PROPOSED SIGNAGE

PRSG20251417

CLIENT:	Fairfield BY MARRIOTT
ADDRESS:	202 15TH AVE SW PUYALLUP, WA 98371
PAGE NO.:	5

D/F ILLUMINATED MONUMENT SIGN

SIMULATED NIGHT VIEW

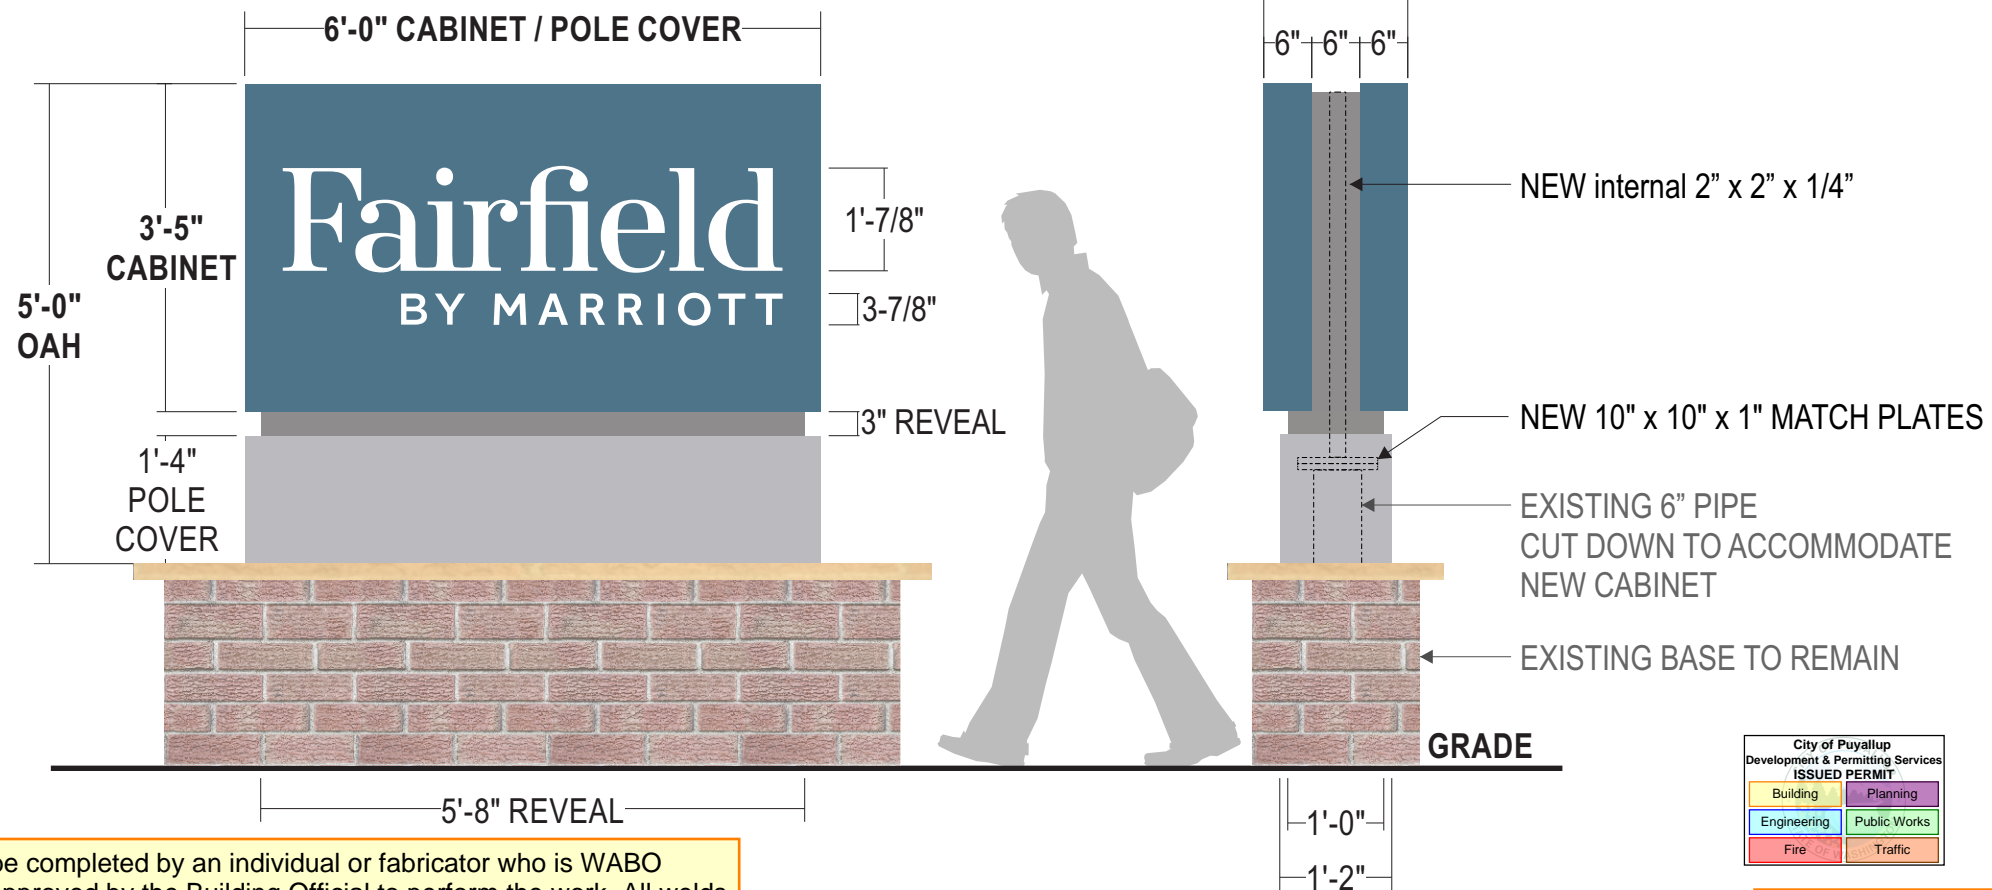
Welding to be completed by an individual or fabricator who is WABO certified or approved by the Building Official to perform the work. All welds must be inspected and approved by a WABO certified special inspector.
